Product Change Notification

MK-009921-SL

Issue Date : 01 April 2016

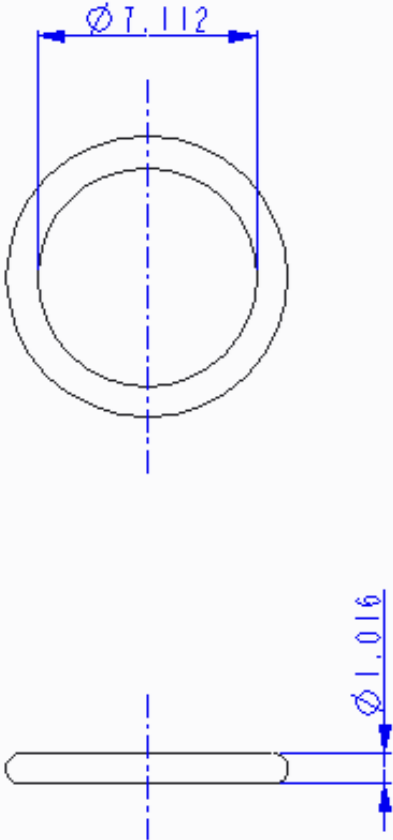
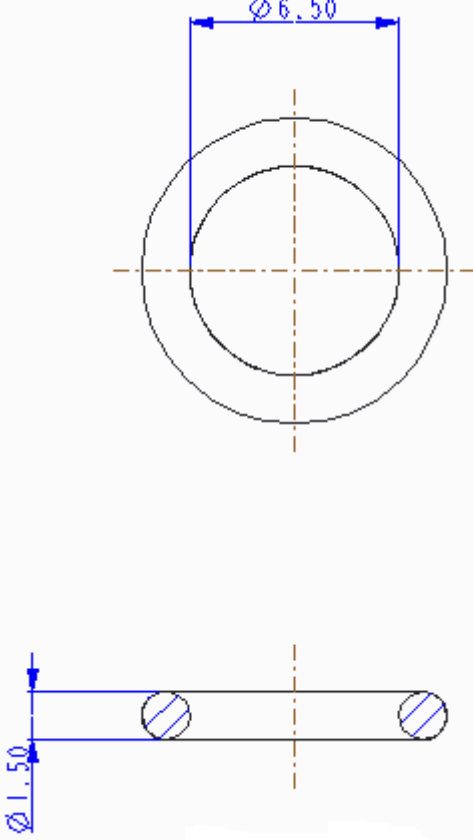
Due to our ongoing product improvement initiatives, it is now proposed to up issue DX1090 and DX1091's in line with this. The changes include the change of the O-ring 12459 to 15163.
